542 Portland Ave

RE: Proposed Second Triplex Development at 540 Portland Avenue

File #: 20-069819, 540 Portland Avenue

540 Portland Avenue: Significant erosion in front yard.

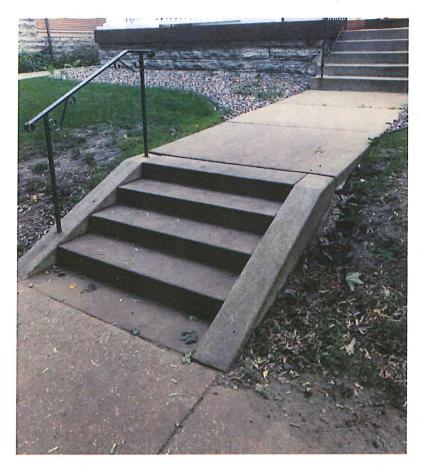
Top photo shows erosion on either side of front stairs, with dirt spreading onto sidewalk.

Bottom photo shows sidewalk covered in dirt due to erosion. It has been like this for years.
